Product Change Notice (PCN)

PCN Number: **PCN-0420160R-01**

Product(s) Affected: **HSB17-404025**

PREVIOUS SAME SKY DETAIL / IMAGE	NEW SAME SKY DETAIL / IMAGE

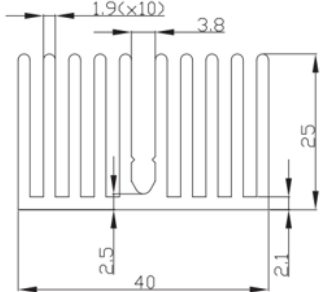
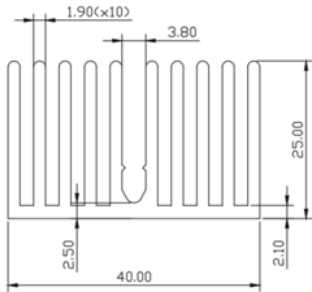
Description of Change: **Product re-engineered for improved manufacturability and production yield. See image below for product changes. Cosmetic differences may be visible and not affect the form fit and function of the product.**
